**ITEM #1 - PRELIMINARY PLAT
DAWSON SUBDIVISION NO. 2**

KPB File No.	2025-123
Plat Committee Meeting:	September 22, 2025
Applicant / Owner:	Terry J. Dawson of Kasilof, Alaska
Surveyor:	John Segesser, Segesser Surveys
General Location:	Yukon Road, Kasilof

STAFF REPORT

Dawson Subdivision No. 2

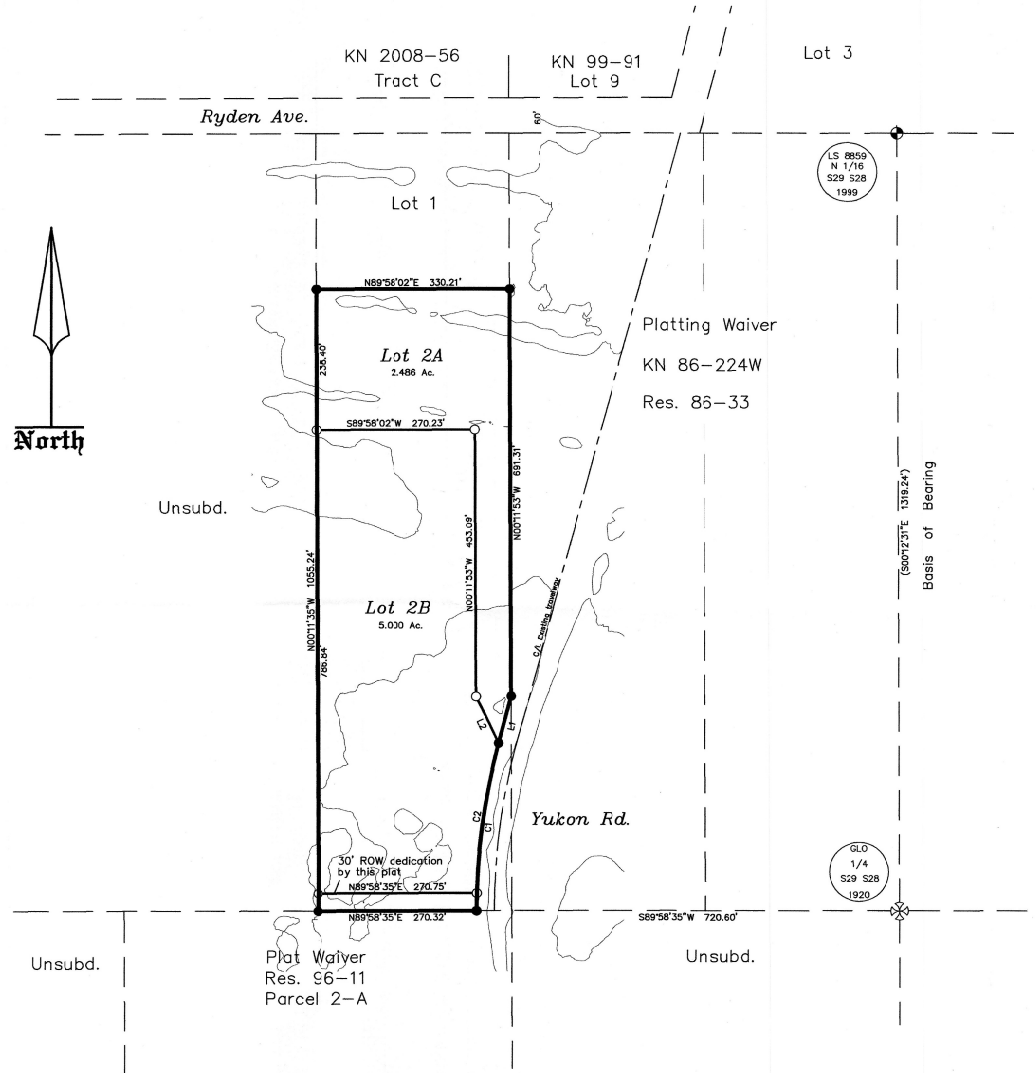
The subject area is relatively flat with no grades exceeding 20% per the KPB GIS terrain layer. Additional contours appear to be depicted on the preliminary plat compared to KPB records. **Staff recommends** at the surveyor's discretion; the contours may be removed on the final plat per KPB 20.60.010. **If kept on final plat**, please confirm contours are depicted accurately.

The access portion of the proposed Lot 2A is 82.13 feet wide at the road and 60 feet wide in the flag portion and complies with KPB 20.30.190 (B) and is subject to the building setback restrictions of KPB 20.30.240. **Staff recommends** place the standard note on the plat for the flag lot: No structures or wastewater disposal are permitted within the panhandle portion of the flag lot [KPB 20.30.190 (B)].

Staff recommends the Wastewater Disposal notes be modified to include the associated lots and be modified if required upon review and approval of Soils Report.

A general easement was granted to Homer Electric Association, Inc. as recorded in Book 10 Page 15, KRD. **Staff recommends** a plat note be added referencing the easement.

A general easement was granted to Glacier State Telephone Company by Book 168, Page 17. **Staff recommends** the easement be added as plat note with referencing the location of the easement as described within the document.

Dawson Subdivision granted a 10-foot utility easement including 20-feet within 5-feet of side lot lines adjacent to all rights-of-way. **Staff recommends** the surveyor depict the utility easement adjacent to Yukon Road with a label referencing the plat granting the easement.

The proposed plat is granting a 10-foot utility easement including 20-feet within 5-feet of side lots adjacent to all rights-of-way. **Staff recommends** the utility easement be depicted and labeled on the plat adjacent to the right-of-way being dedicated.

- Modify KPB File Number to 2025-123
- Modify the meeting date to September 22, 2025 on Plat Approval

- Modify the KPB File No to 2025-123
- Include Third Judicial District within legal description

- Label ROW width for Yukon Road

- Please label the depiction of Coal Creek located within sections 18, 17 and 16
- Remove the label for township 2 north
- Include a label for Pollard Loop Road

- Provide new ROW name to Addressing Officer for review and approval prior to final
- Add CTP items #4 & #5

- Include Plat Info for Lot 3 (KN 99-91) and Lot 1 (KN 2008-86)
- Modify the Resolution number to 86-23 KN 86-224W
- For clarity, provide the book and page number (Book 484 Page 167 KN) for Res. 96-11
- For clarity, modify the label for the southeast parcel to: Plat Waiver Res., 89-11, Parcel 1, KN 89-9
